Project  
PROPOSED MIXED USE DEVELOPMENT

684-700 CANTERBURY ROAD  
BELMORE  
Drawing Title  
SHADOW DIAGRAMS

DA SUBMISSION			
Job no.	Drawing no.	Rev.	
J18433D	DA 6001	E	
Drawn by	Checked by	Approved by	Date
AL	RJ	JY	AUG. 2018

Drawing Title  
GFA CALCULATION

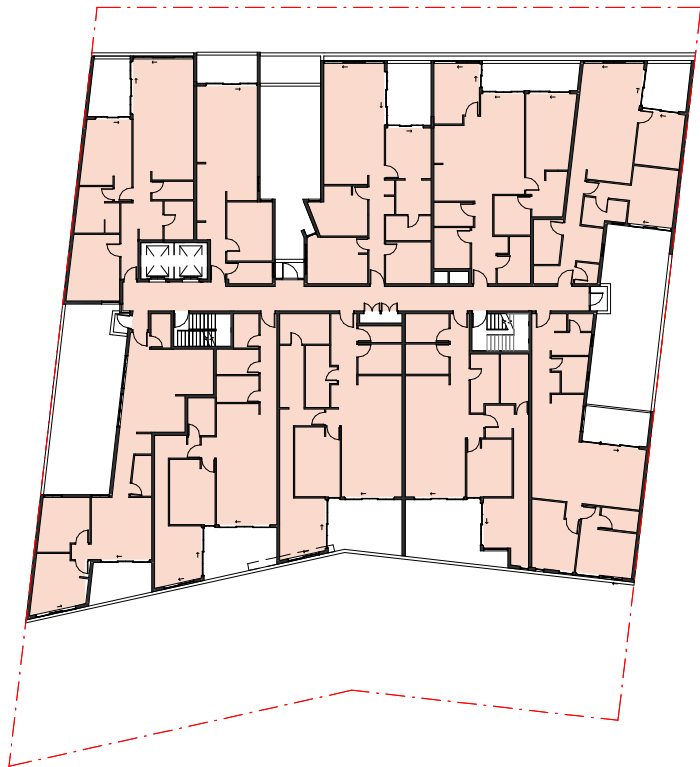
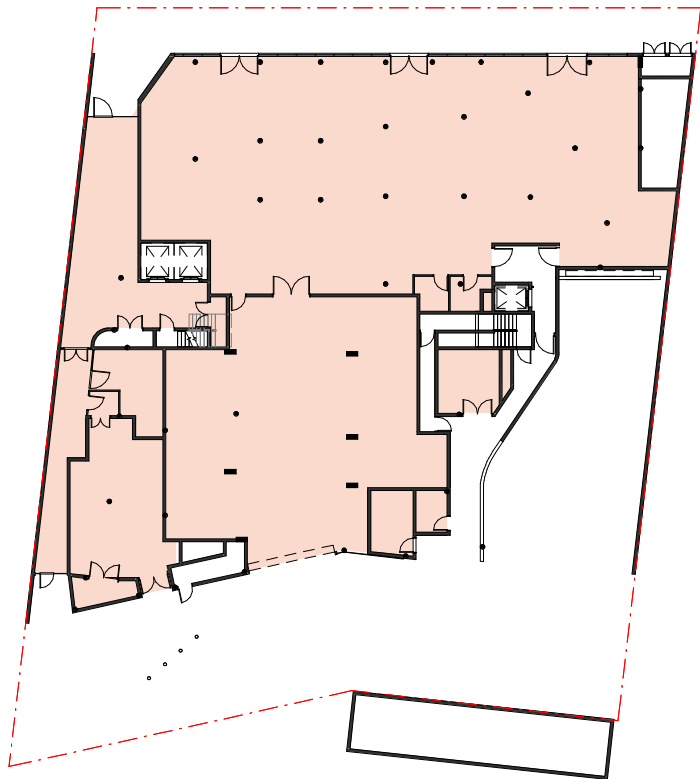
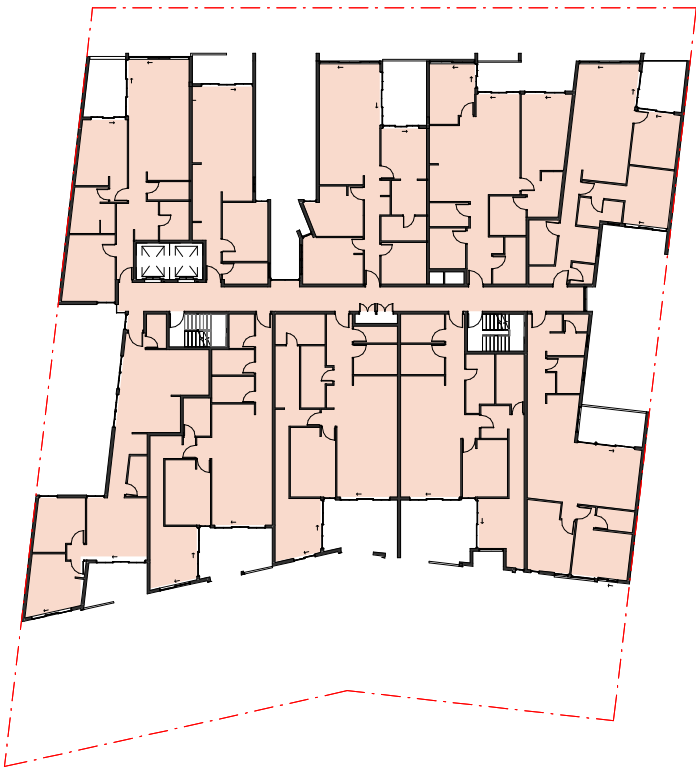
List of Changes: 23.05.22  
• GFA diagrams revised  
• GFA schedule revised

Drawing Title  
**COMMON OPEN SPACE DIAGRAM**

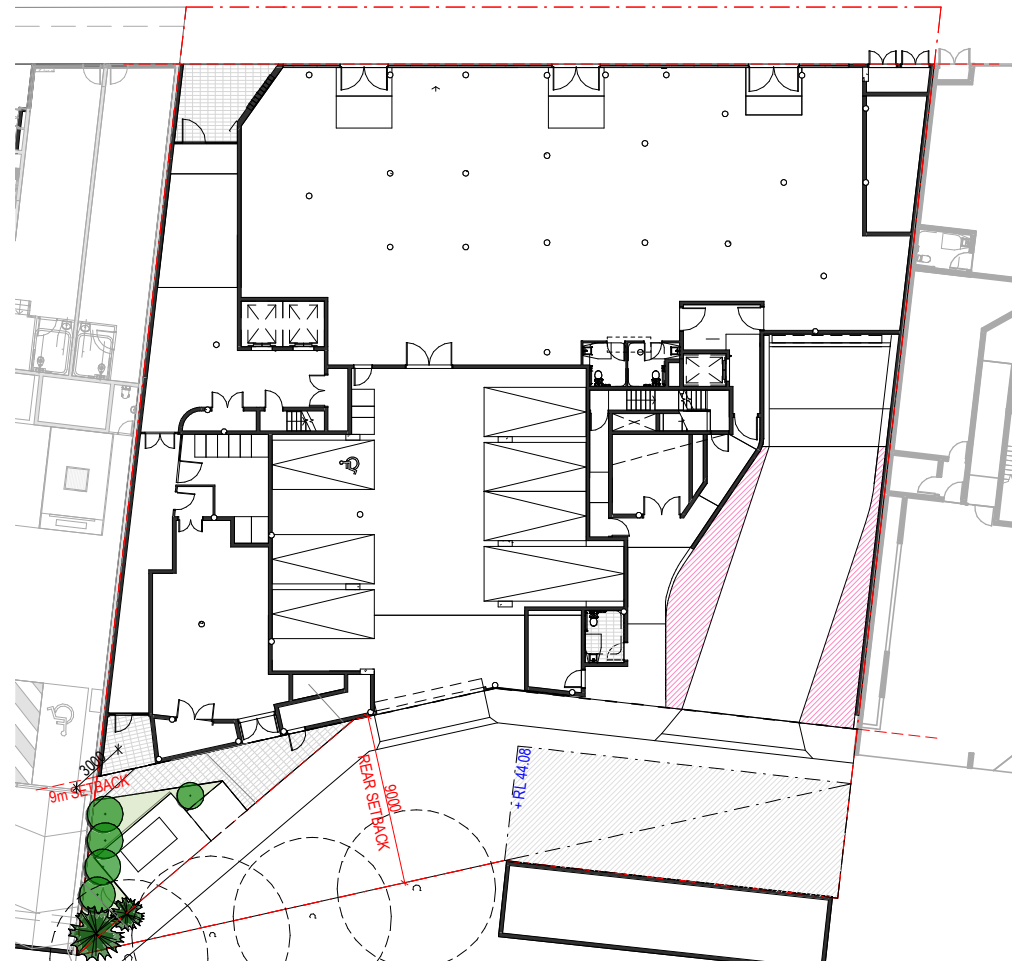
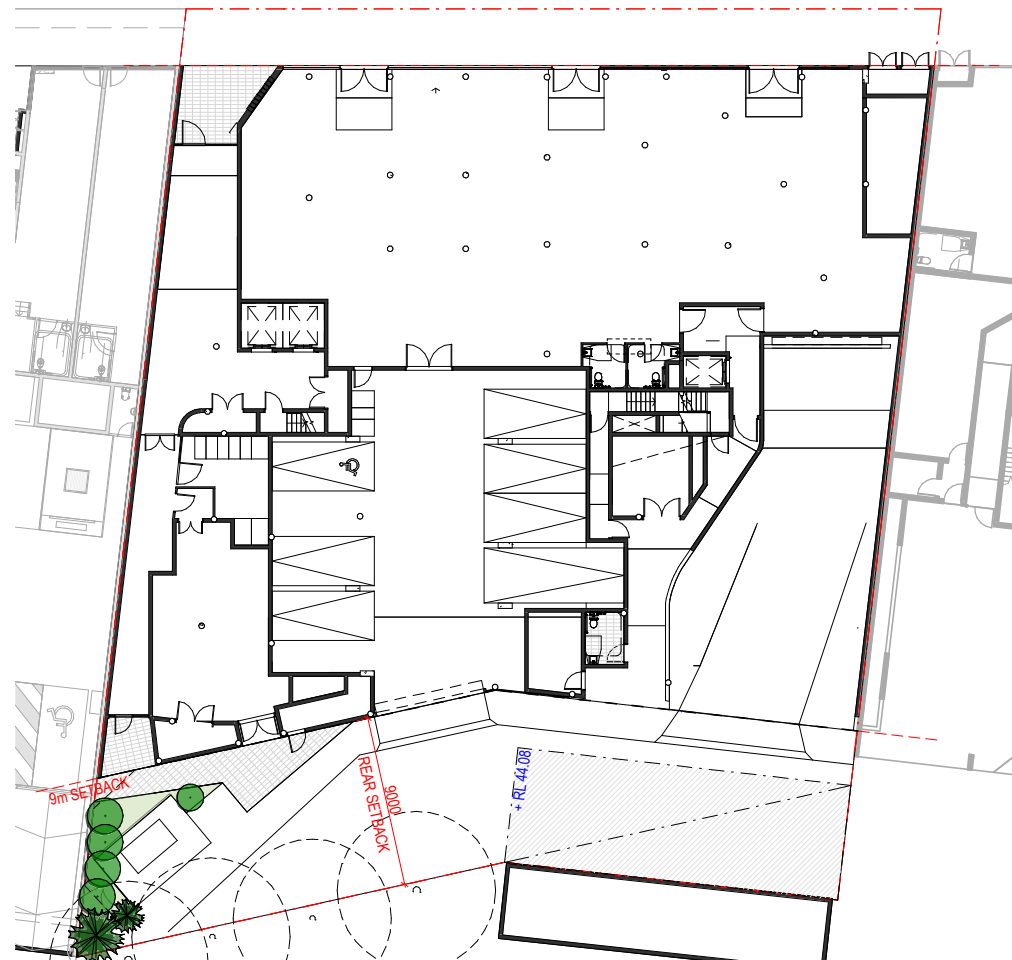
List of Changes: 23.05.22  
• COS diagrams revised  
• calculation revised

**COMMON OPEN SPACE SOLAR DIAGRAMS**

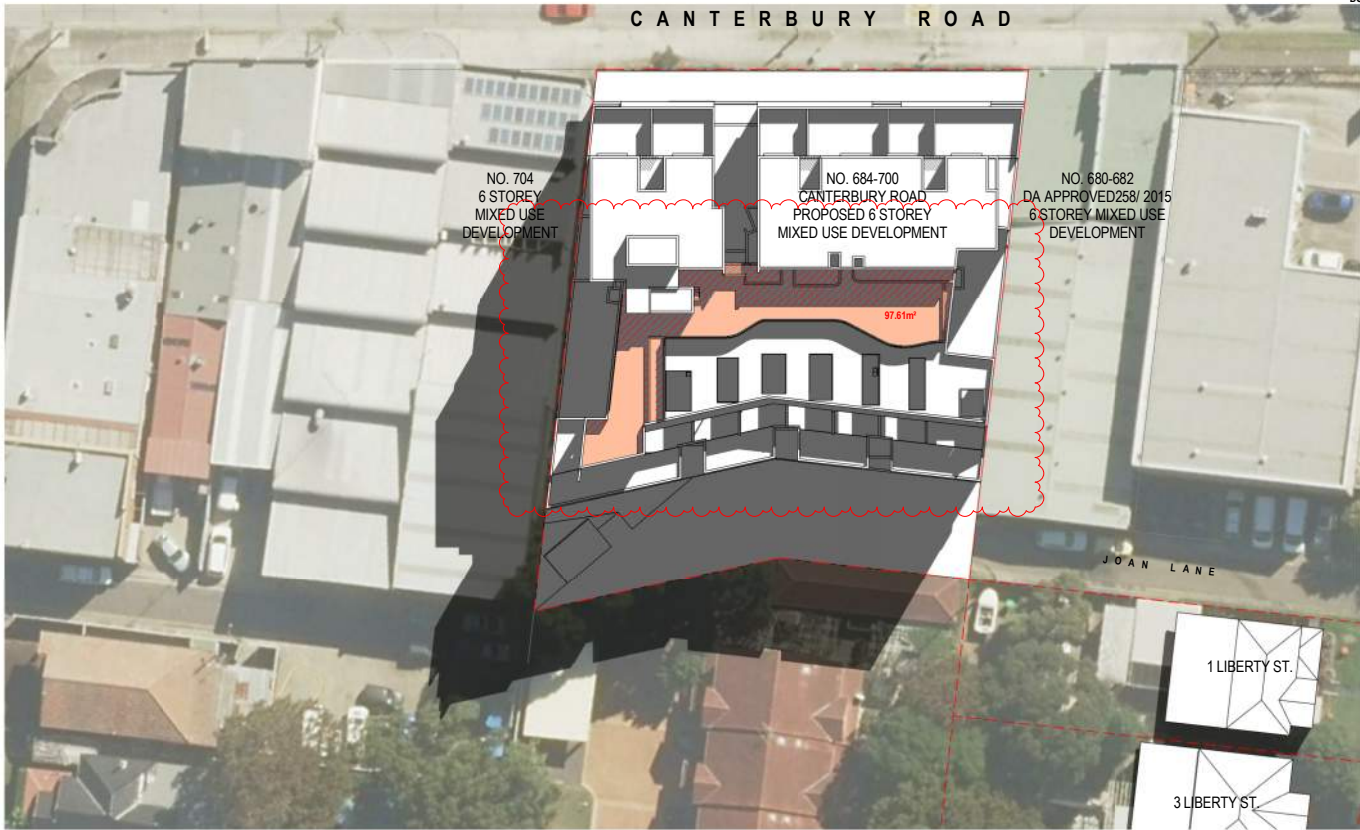
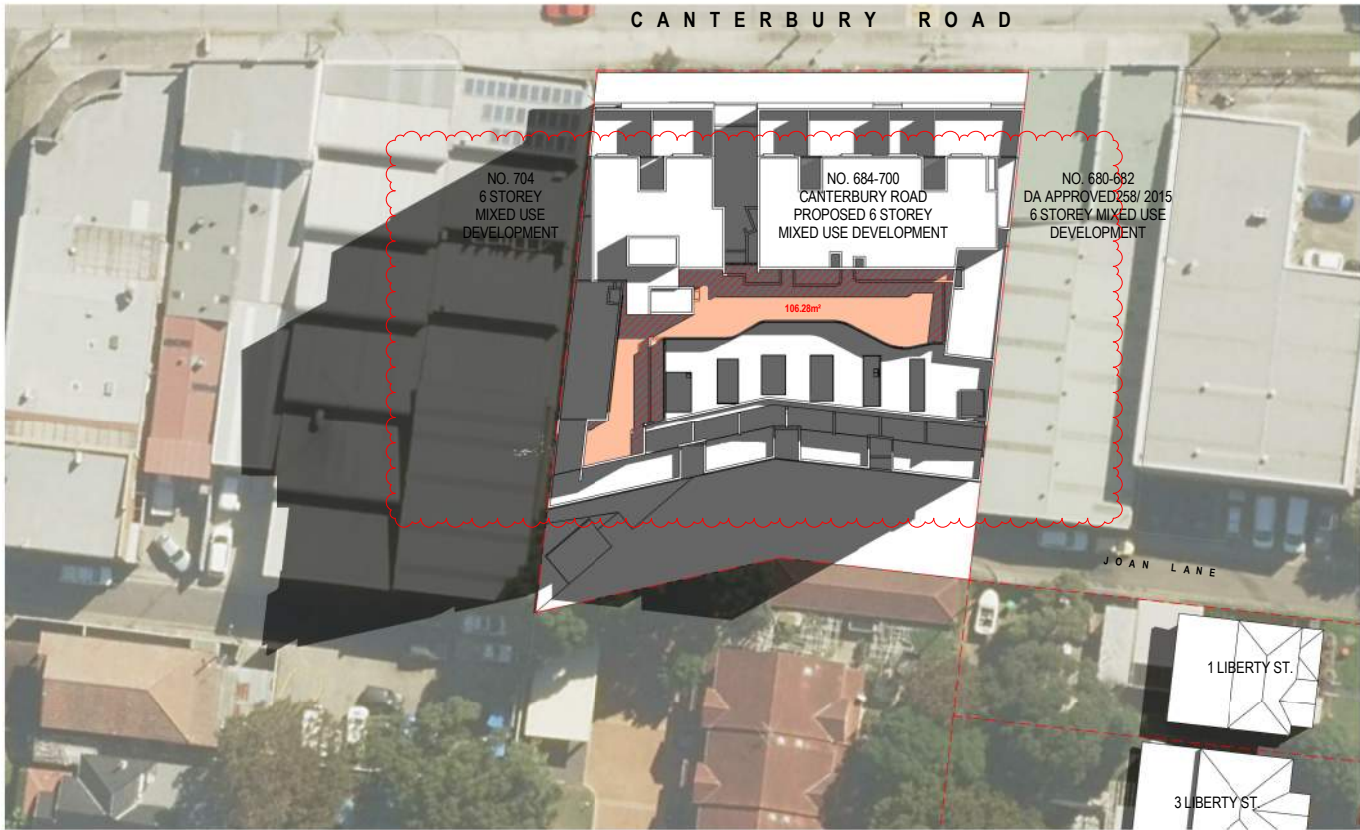
List of Changes: 23.05.22  
• Solar Diagrams updated

**LEP HEIGHT BLANKET DIAGRAM VIEW 1**

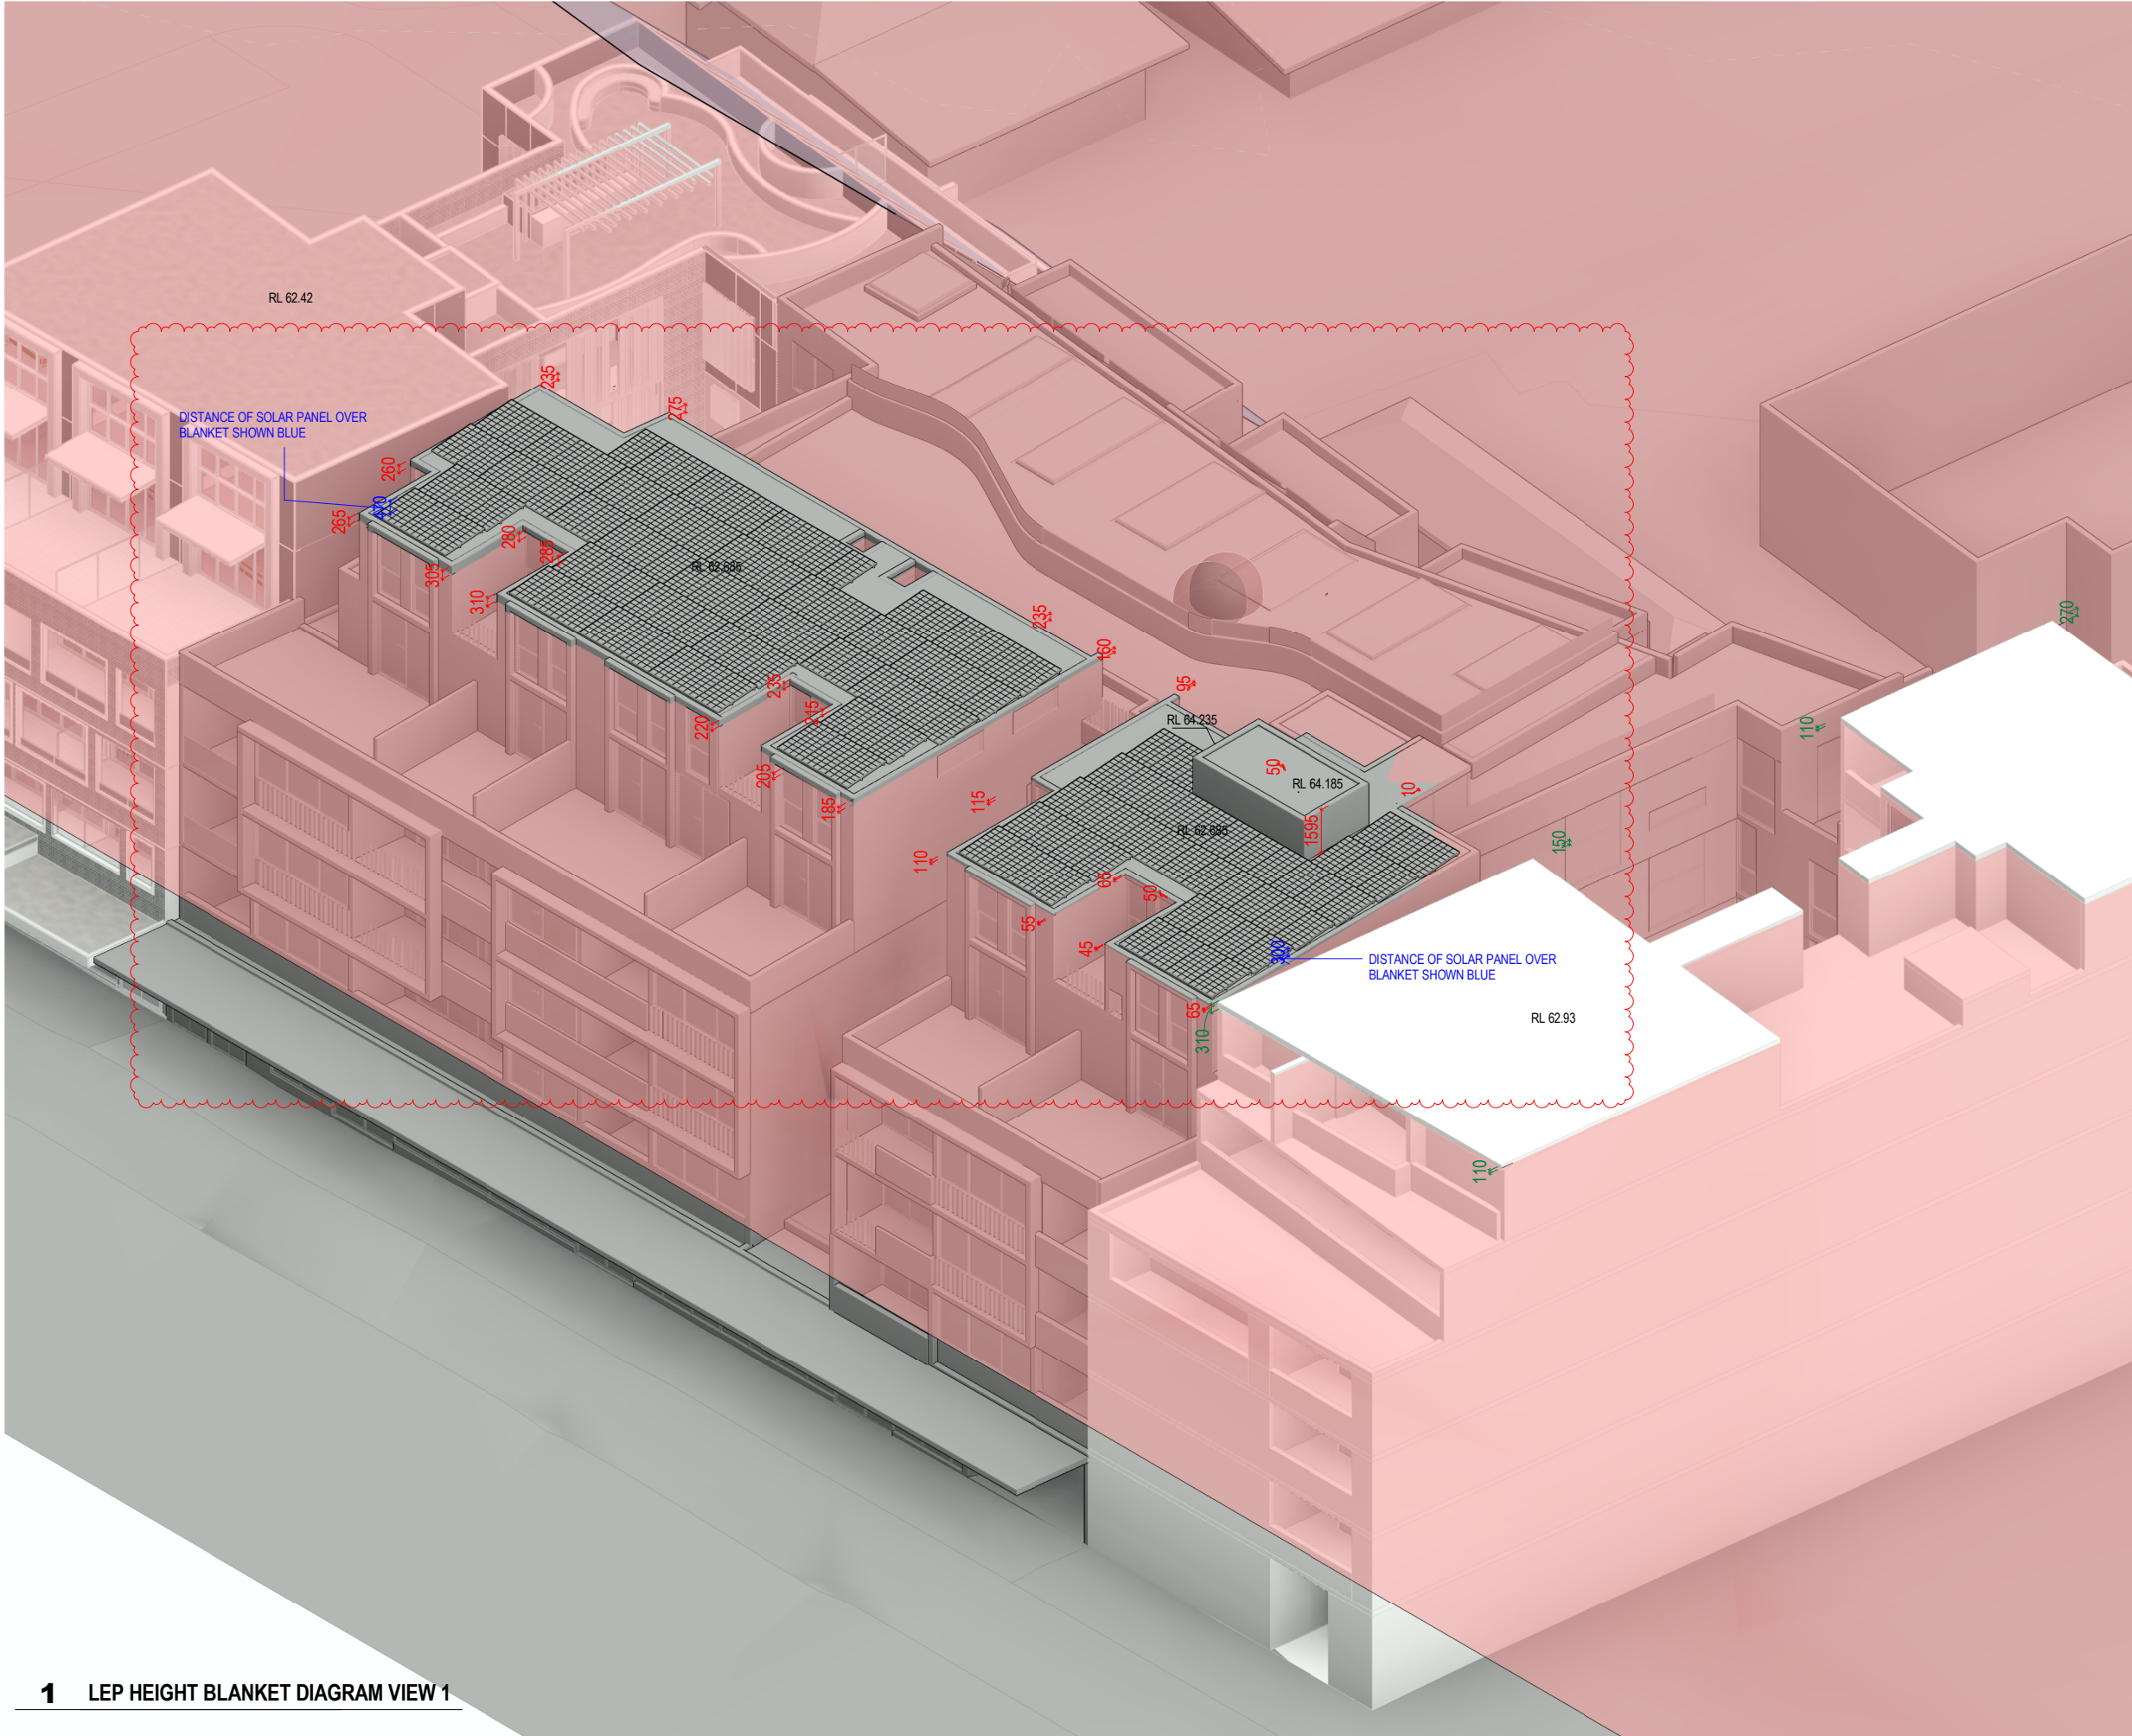
List of Changes: 23.05.22

- Blanket diagram revised as per changes on elevations and floor plans
